**CITY OF FLORENCE
PLANNING COMMISSION**

RESOLUTION 03-12-30-41

IN THE MATTER OF A REQUEST FOR APPROVAL OF A MODIFICATION TO THE SANDPINES PLANNED UNIT DEVELOPMENT, A TOTAL OF 242 ACRES, LOCATED NORTH OF 35TH STREET, WEST OF OAK STREET, EAST OF RHODODENDRON DRIVE, MAP REFERENCE 18-12-15, TAX LOTS 400-1000, 1400 &1500, AND 18-12-15-33, TAX LOTS 100&700 AND 18-12-22-21, TAX LOTS 1900 AND 18-12-22 BLOCKS 8, 10-13, 3000-5300, 10900-15100 AS APPLIED FOR BY MYHRE GROUP ARCHITECTS FOR ARIKI-OREGON, LTD.

**Revised Exhibit "A"
Findings of Fact
January 13, 2004
Resolution 03-12-30-41**

- ⑩ BICYCLE LANE (PERFORMED THERMOPLASTIC)
- ⑪ CROSSWALKS (PERFORMED THERMOPLASTIC)
ALIGN GAPS WITH WHEEL PATHS

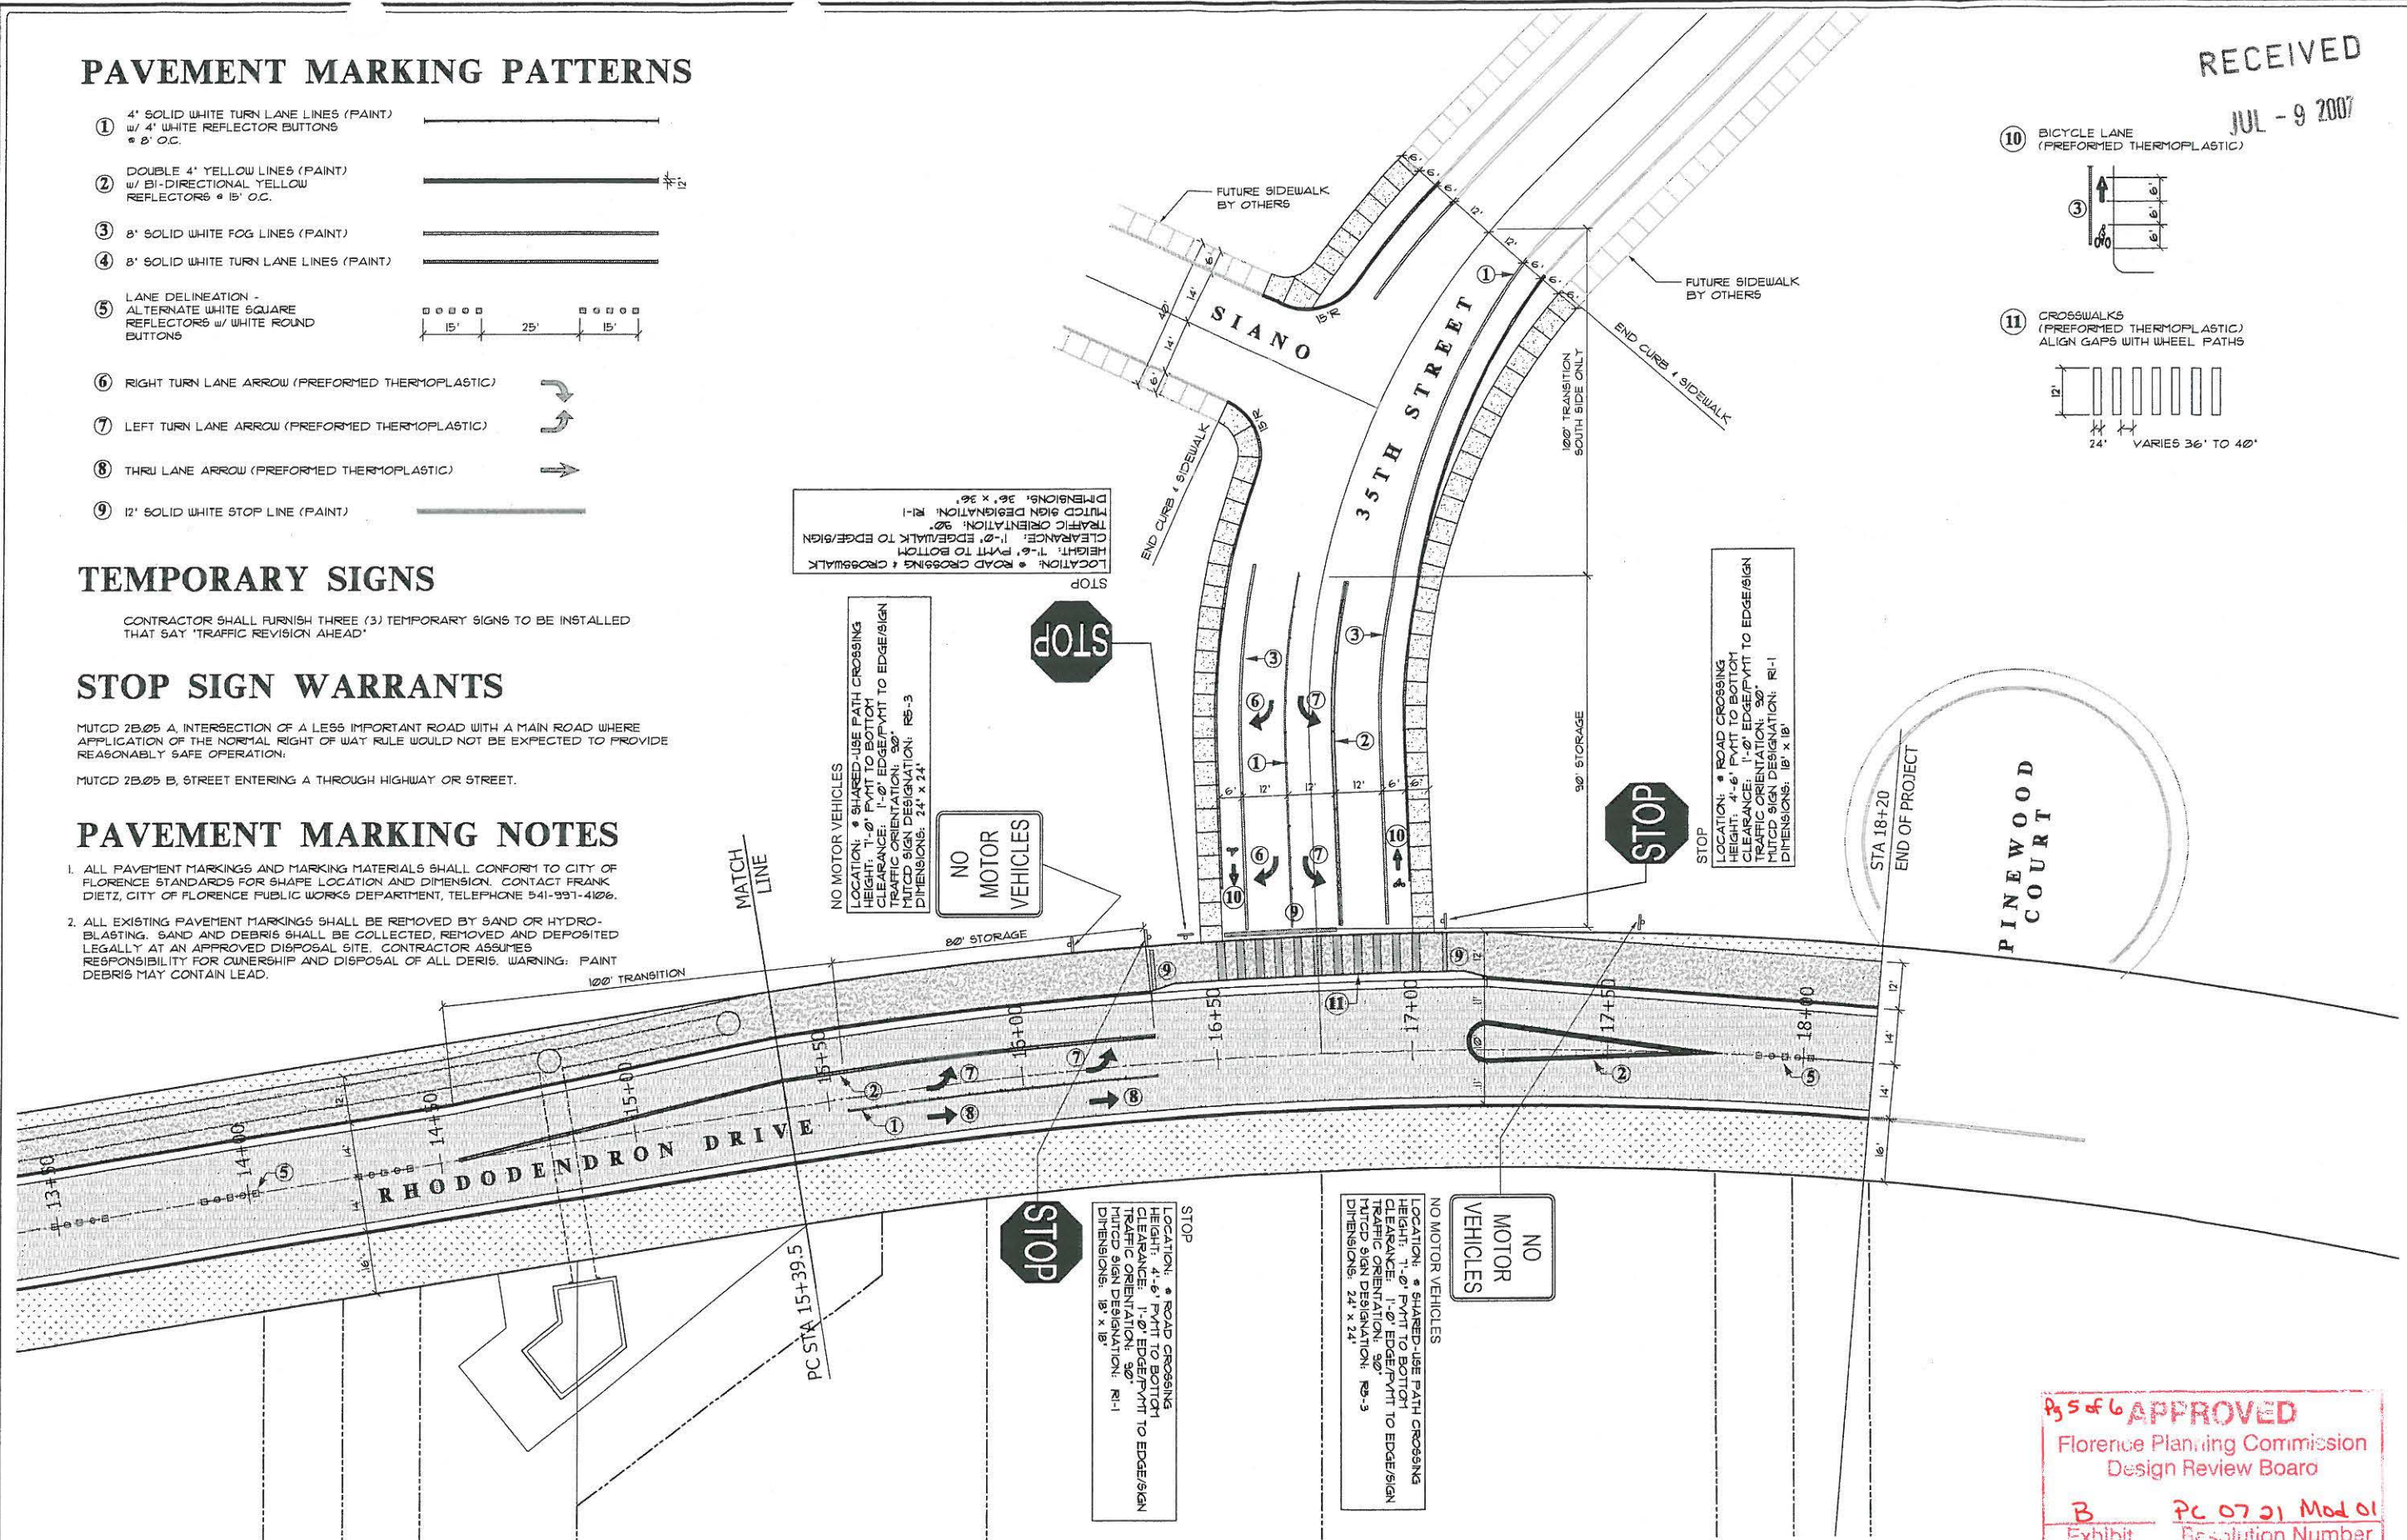
Exhibit B
Modifications to Condition of Approval
Sandpines II and III
Preliminary Traffic Plans

**Sandpines Residential Phases II & III
Revised Stormwater Management Plan**

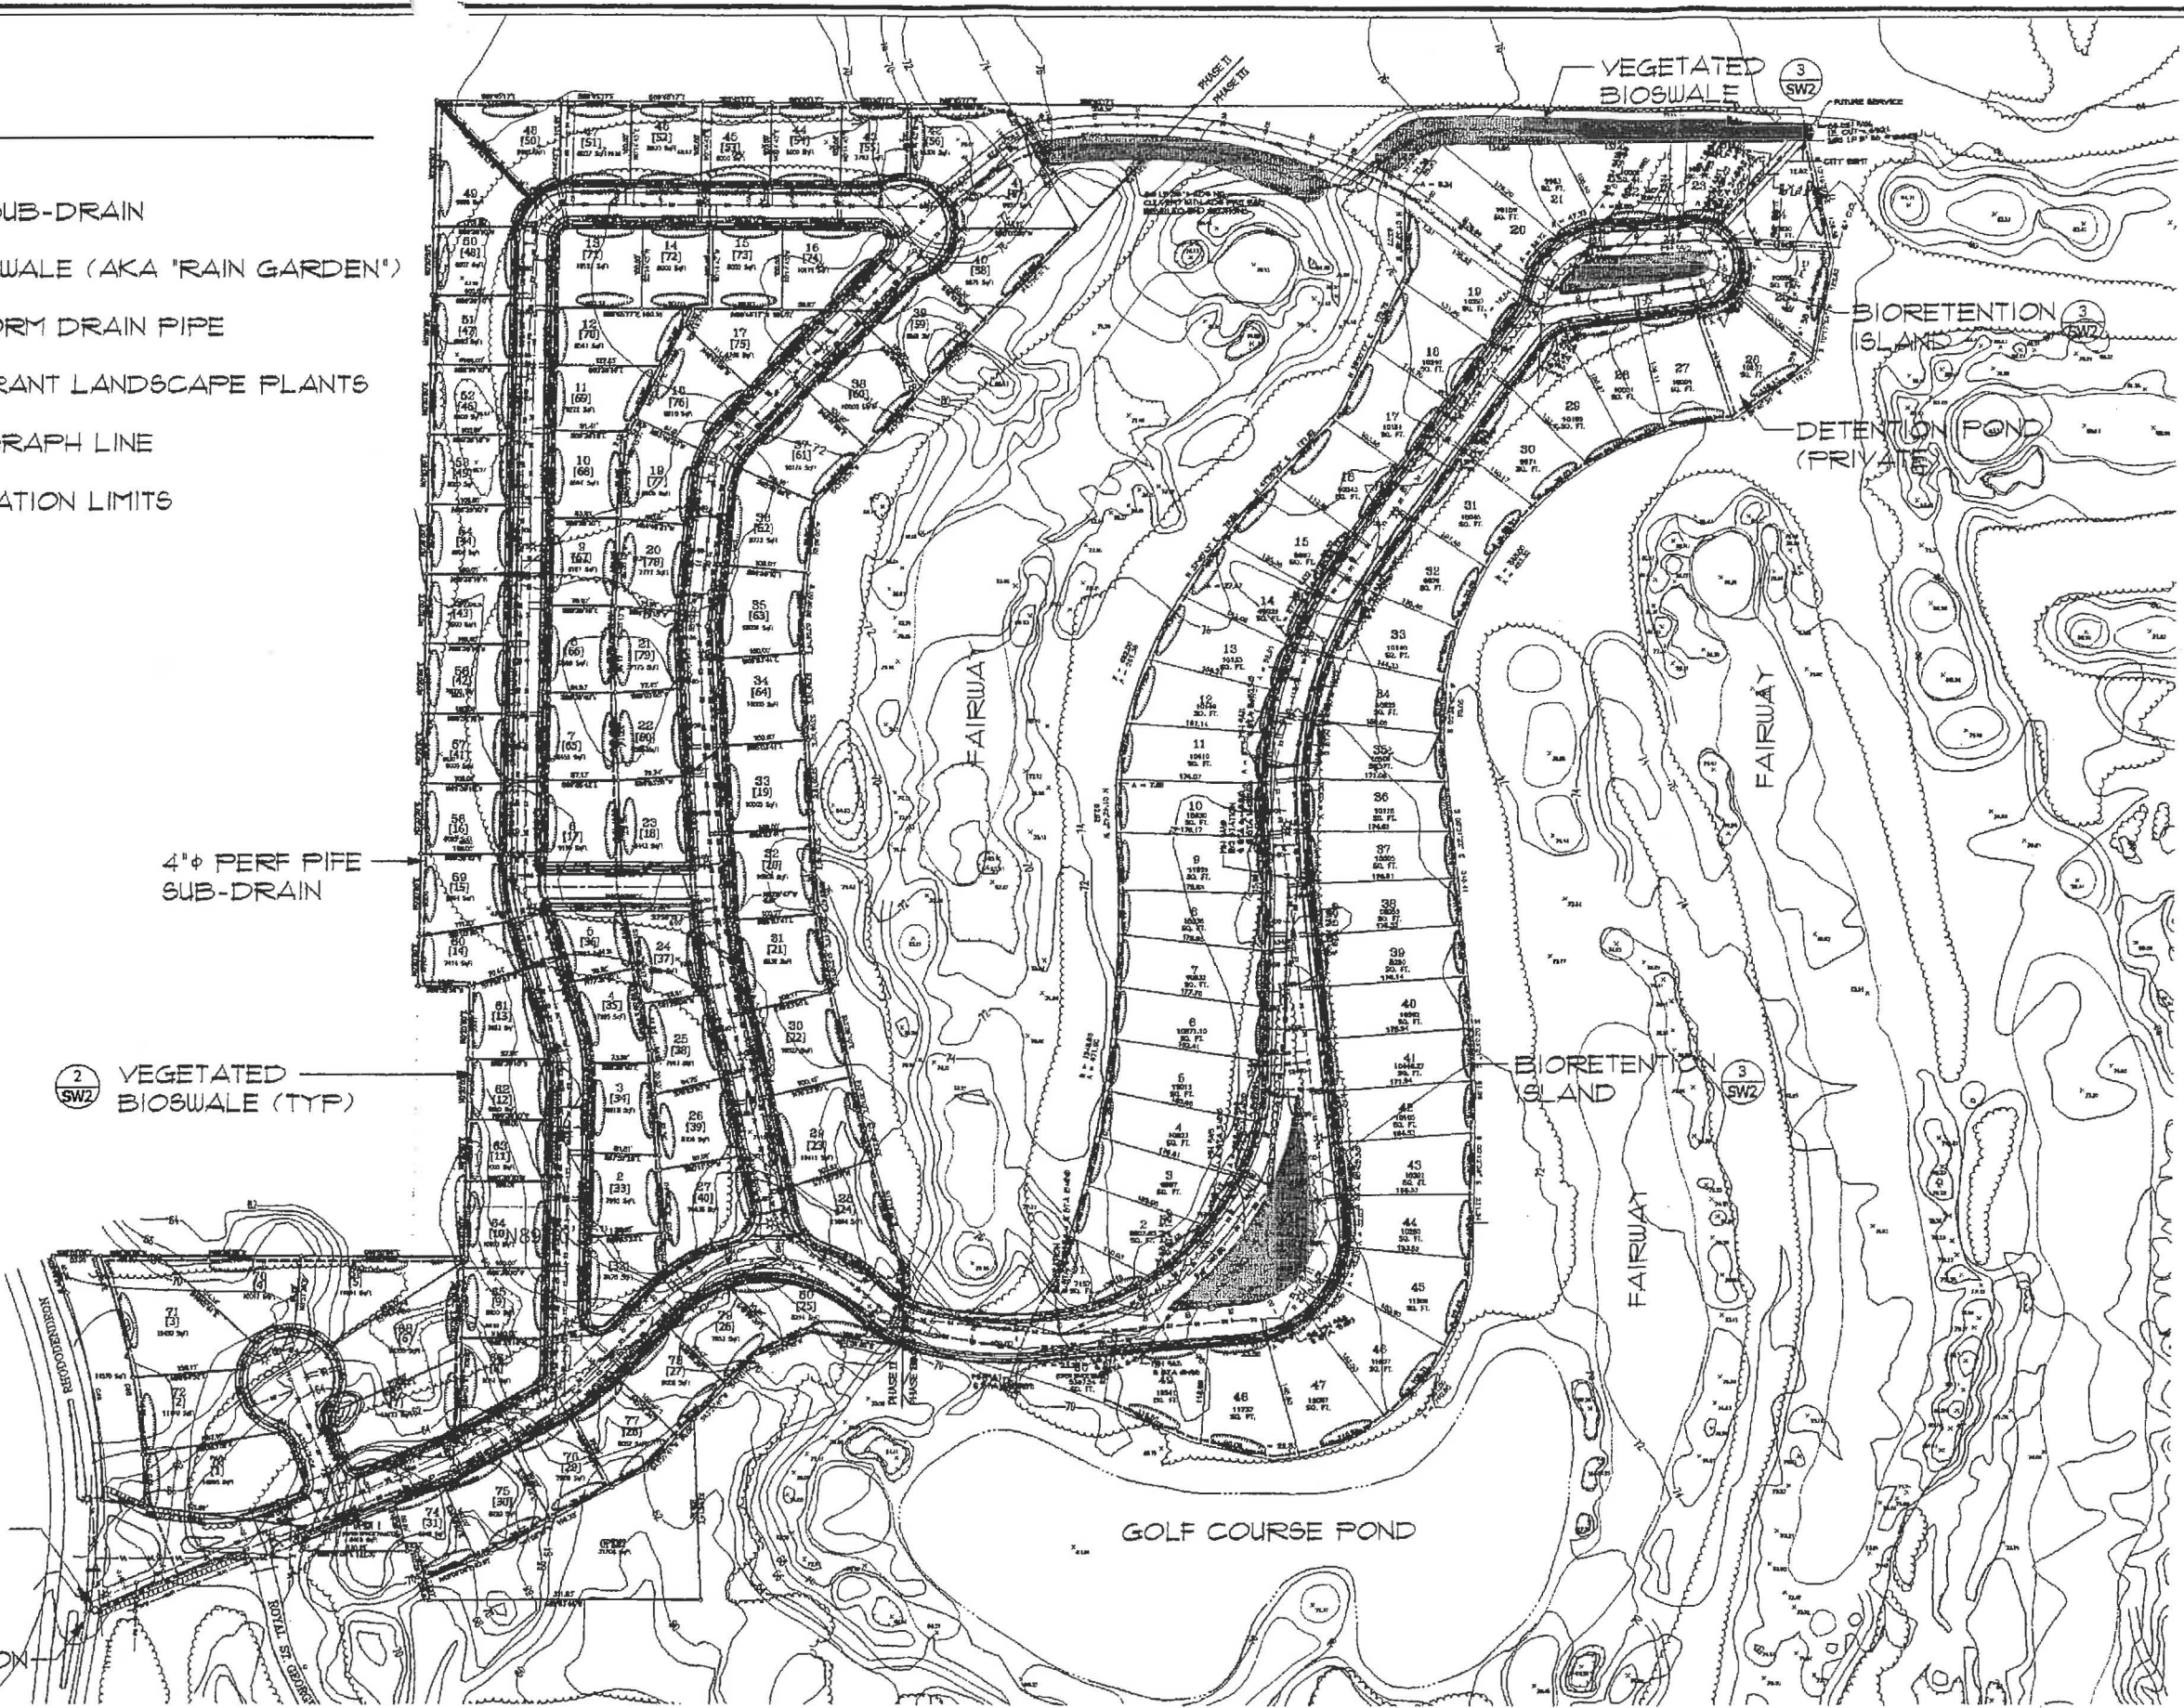
- A. Complete Revised stormwater plan for Sandpines Phases II and III

15. **Stormwater Management** - Due to the sensitive groundwater conditions in the area, and the unimproved status of the downstream conveyance system, the applicant shall revise the stormwater plan to improve the downstream conveyance system extending from the site to the outfall at the Siuslaw River. This improvement can be designed to allow the development to increase the surface water runoff from the site.

17. **Calculated Flows:** The applicant's revised stormwater plan shall include calculated flow rates from the dewatering system, and a description of the significance of these flows to the downstream system.
